632AW TYPE TELEPHONE SET

A-579206

632 TYPE TEL SET WIRING DIAGRAM & CIRCUIT LABEL P-12E419

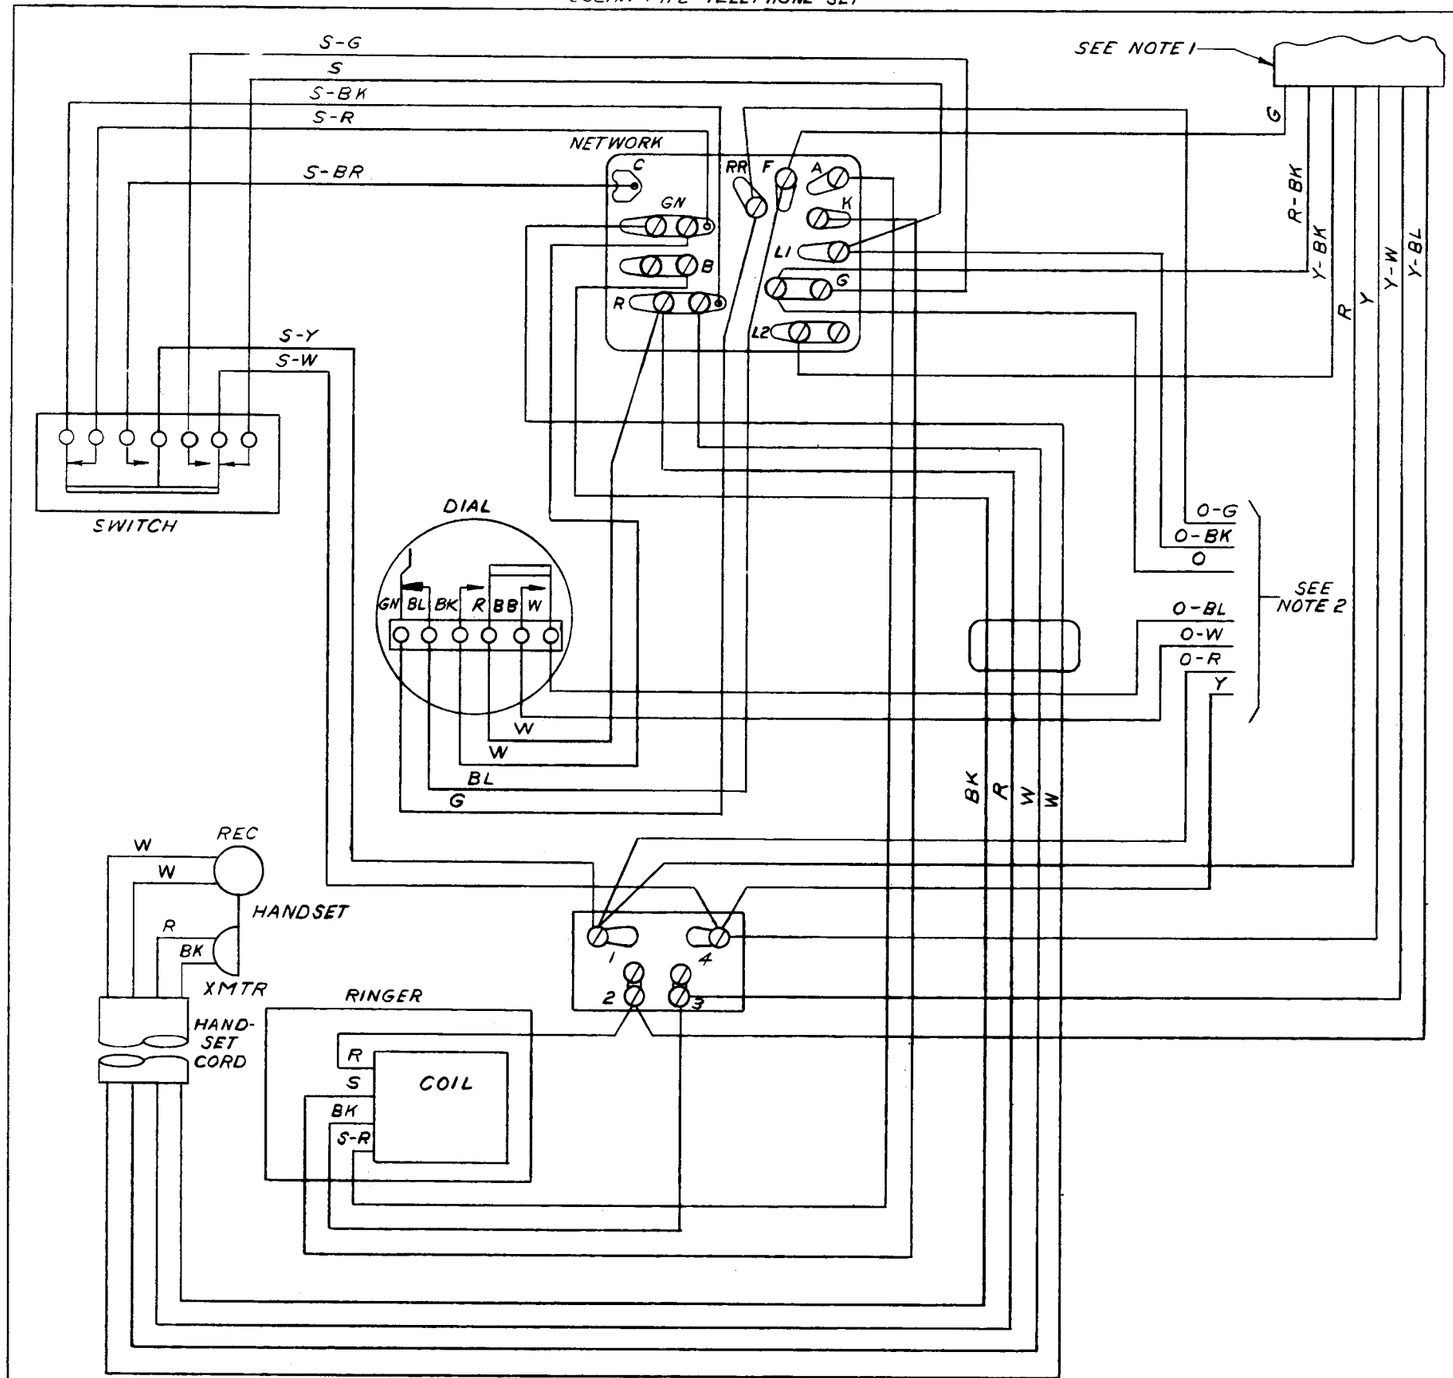
ISSUE-7 12-8-60
CHANGED: RINGER LEADS "S" AND "S-R" CONNECTED TO TERMINALS K AND A, RESP. OF THE NETWORK WERE CONNECTED TO TERMINALS A AND K, RESP.; DIAL CONTACTS BK AND R WERE SHOWN REVERSED WITH "W" LEADS FROM DIAL CONTACTS BK AND R TO NETWORK TERMINALS GN AND R, RESP. CHANGED ACCORDINGLY; DIAL CONTACTS G AND BL WERE SHOWN OPEN; ISSUE NO. FOR CIRCUIT LABEL P-12E419 WAS 4 (442230-B1)

ISSUE-8 5-1-61
CHANGED: ON CIRCUIT LABEL 632 TYPE WAS 632AW1-13 ISSUE WAS 5 (E1R 632AW1 & 1S TEL SET)
